VALIDATION REPORT

RODEIO BONITO SMALL HYDRO POWER PROJECT IN BRAZIL

REPORT No. 2008-1120

Project Name: Rodeio Bonito Small Hydro Power Project

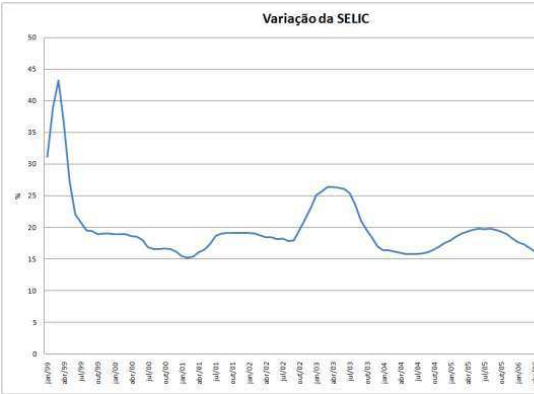
Draft report clarifications and corrective action requests by validation team	Ref. to checklist question in table 2	Summary of project owner response	Validation team conclusion
		<p>borrowed. Project participant was created in 2005 and had no such guarantees. In other words, project participant will have to use its own balance sheet and capital to raise funds from BNDES. In case project underperform or become unfeasible, BNDES would call project participant's guarantees and real assets up to their initial credit exposure. In addition to leveraging their balance sheet with sizeable borrowings, project participant would face completion risk of the project. Completion risk is mitigated by guarantees pledged by the construction company; which are however, of limited recourse. These necessary guarantees, costs and risks associated were considered very excessive by the project participant and understood as a barrier.</p> <p>As required for ii), the project participant provided an investment analysis of Rodeio Bonito project. Shareholders IRR will be used as project financial indicator and as reference to represent the standard returns in the market the Brazilian interest rate will</p>

Draft report clarifications and corrective action requests by validation team	Ref. to checklist question in table 2	Summary of project owner response	Validation team conclusion
		<p>involving banks that buy and that you/they sell those titles. Therefore, the Selic rate is the rate that remunerates the investors in the purchase business and sale of public titles.</p> <p>The qualified financial institutions, such as banks, savings banks, society's brokers of titles and values furniture, distributing societies of titles are capable to make this kind of operation.</p> <p>The most liquid government bond is the LFT (floating rate bonds based on the daily reference rate of the Central Bank of Brazil). As of January 2006, 37% of the domestic federal debt was in LFTs and had duration of one day (Source: Tesouro Nacional; www.tesouro.fazenda.gov.br). This bond rate almost follows the CDI rate, which is influenced by the SELIC rate, defined by COPOM.</p> <p>The SELIC rate has been oscillating since 1999, from a minimum of 11.73% a.a. in July 2007 up to a maximum of 43.25% a.a. in January 2003</p>

Draft report clarifications and corrective action requests by validation team	Ref. to checklist question in table 2	Summary of project owner response	Validation team conclusion
		<p>(see here below) .</p>  <p>(Source: Banco Central do Brasil)</p> <p>In order to be conservative, it will be considered the the average value of 2 years before the investment decision. From January 2005 to December 2006, the average value for the SELIC was 17 %. The Rodeio Bonito project investment analysis</p>

Draft report clarifications and corrective action requests by validation team	Ref. to checklist question in table 2	Summary of project owner response	Validation team conclusion
		<p>was made end of 2006. The cash flow provided by the project participant was verified by external auditors and present an IRR value of 13,33 % without carbon credits revenues. This value is 3,67 % inferior to the benchmark value.</p> <p>This shows that without CER revenues, the project would reach lower rates of return than the benchmark rate, concluding that the project activity <i>cannot be considered as financially attractive</i>.</p>
